HISTORIC AND DESIGN REVIEW COMMISSION

October 07, 2020

HDRC CASE NO: 2020-403
ADDRESS: 1903 W MULBERRY AVE
LEGAL DESCRIPTION: NCB 1944 BLK 22 LOT 1
ZONING: R-6, H
CITY COUNCIL DIST.: 7
DISTRICT: Monticello Park Historic District
APPLICANT: Mario Cordero/CORDERO MARIO J & SYLVIA R
OWNER: Mario Cordero/CORDERO MARIO J & SYLVIA R
TYPE OF WORK: Replace existing garage doors and replace siding
APPLICATION RECEIVED: September 08, 2020
60-DAY REVIEW: Not applicable due to City Council Emergency Orders
CASE MANAGER: Huy Pham
REQUEST:

The applicant is requesting a Certificate of Appropriateness for approval to rehabilitate the rear garage structure to include:

PROPOSED NEW GARAGE DOORS

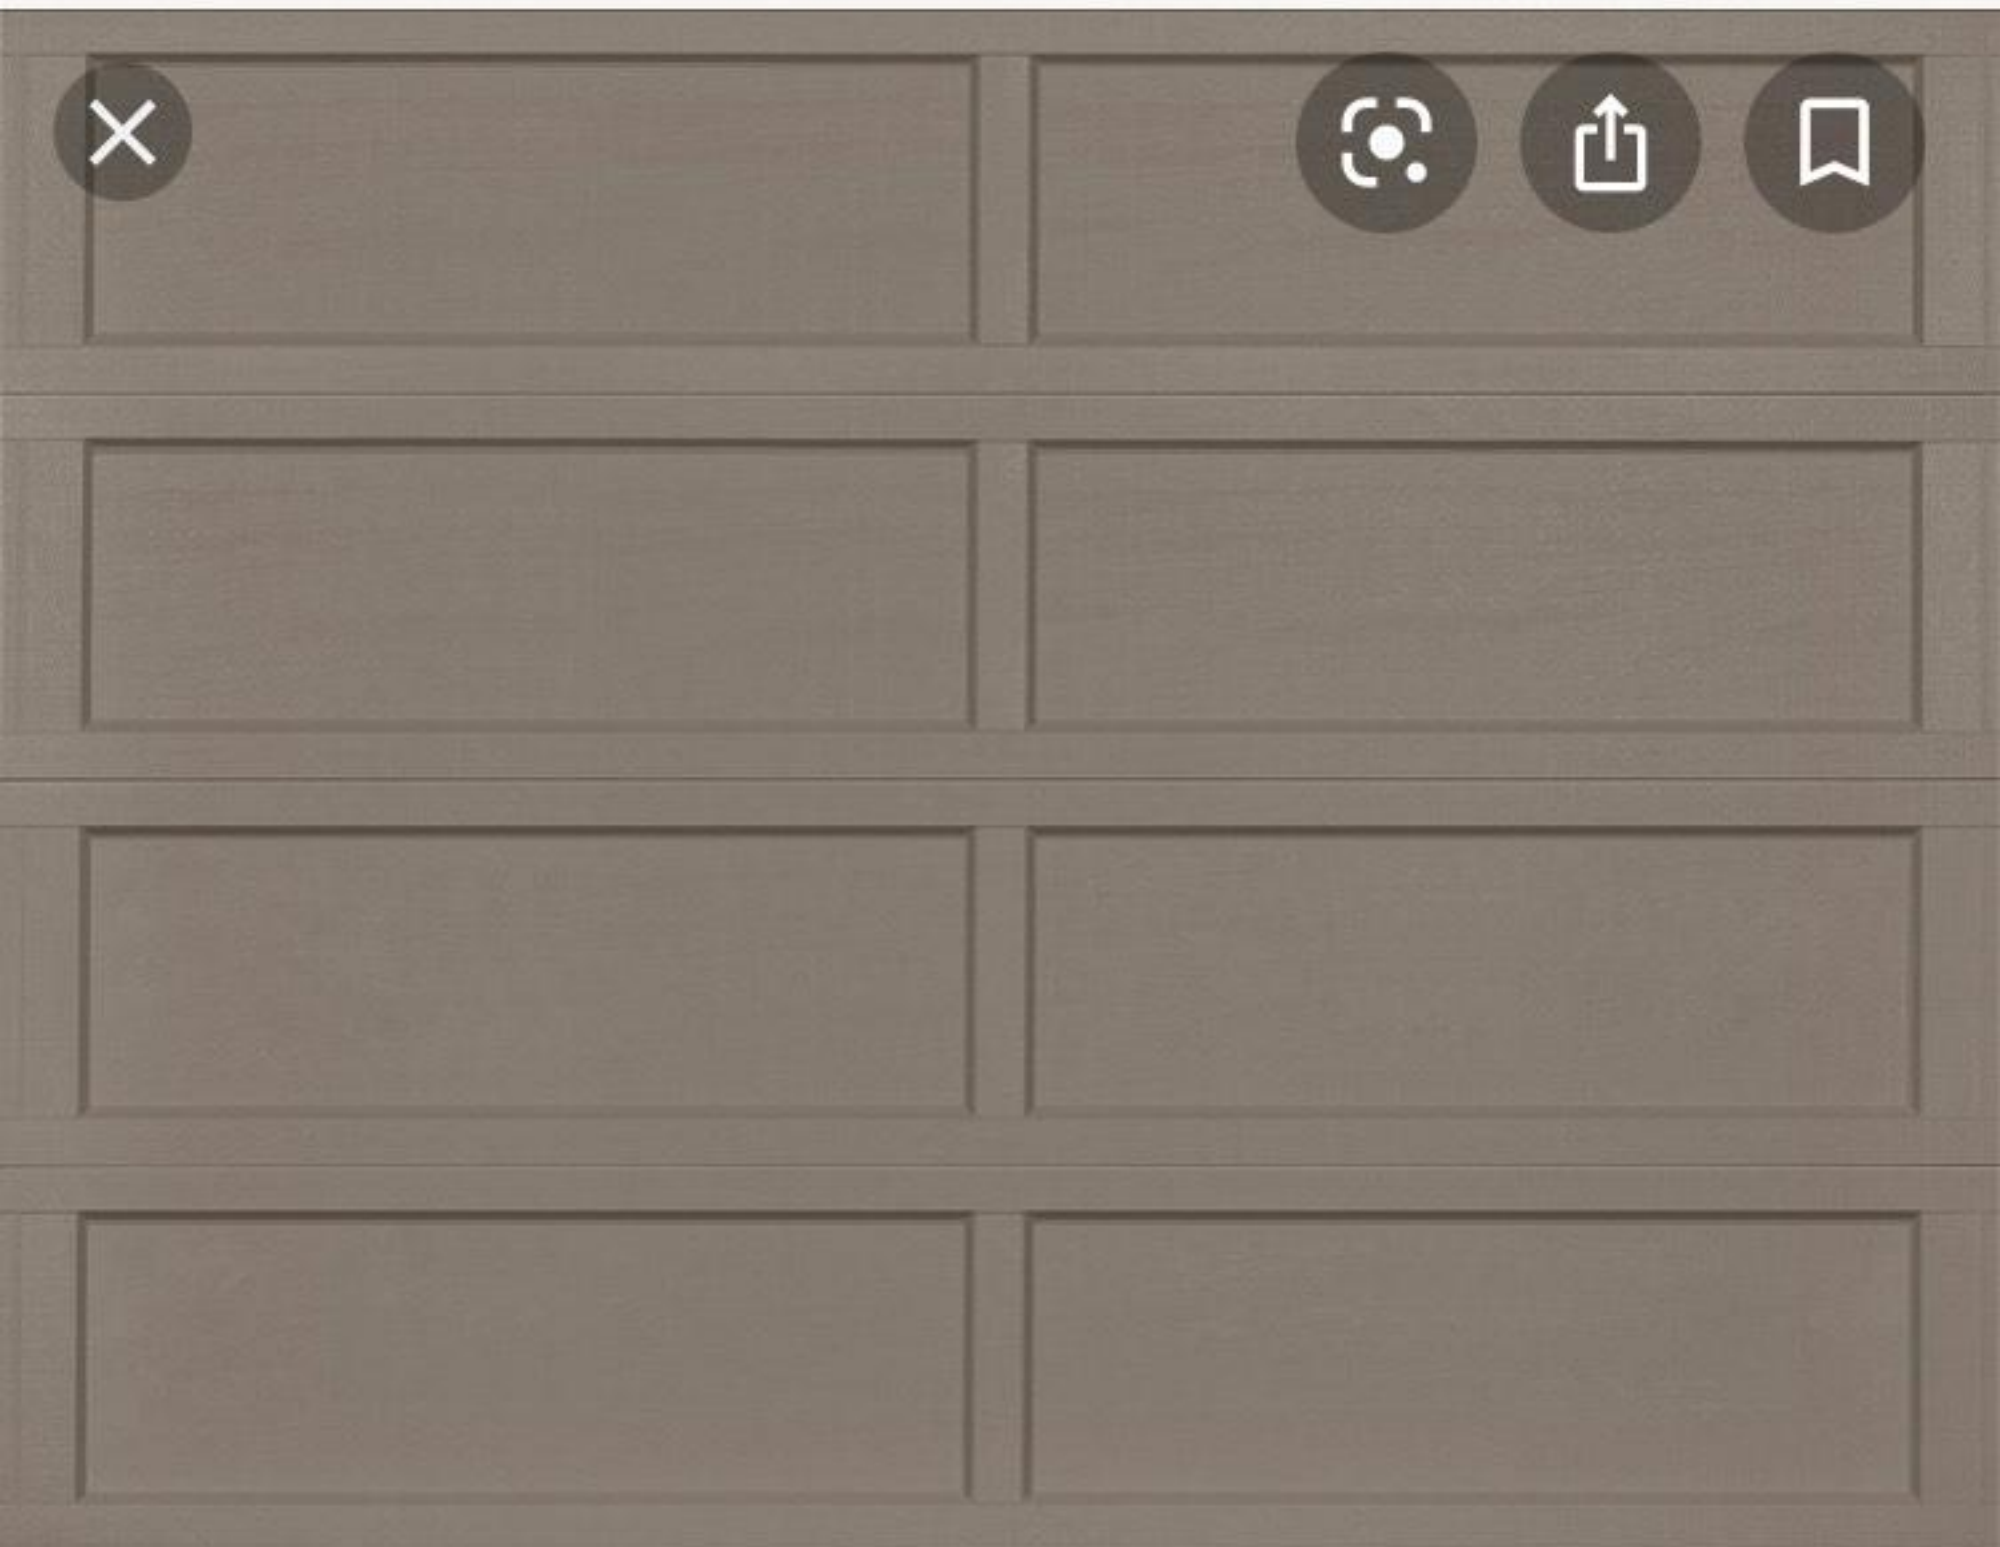
- d. GARAGE DOORS – The applicant has proposed to replace the original wood garage doors with new aluminum garage doors. The doors were discarded prior to approval. Per the Guidelines for Exterior Maintenance and Alterations 9.B.i., applicants should ensure that replacement garage doors are compatible with those found on historic garages in the district (e.g., wood paneled) as well as with the principal structure; when not visible from the public right-of-way, modern paneled garage doors may be acceptable. Staff finds that the doors are highly visible from the public right-of-way and should be reconstructed in-kind with wood and similar panel configuration.

Staff recommends approval of item 1 and 2 based on findings c and d with the following stipulations:

- i. That the replacement Hardie siding feature a profile of four (4) inches and a smooth finish. Additionally, staff recommends that the addition on the south elevation maintain the inset to differentiate itself from the primary accessory structure. The corner trim profile may be re-installed.
- ii. That the garage doors reconstructed in-kind with wood material and similar panel configuration.
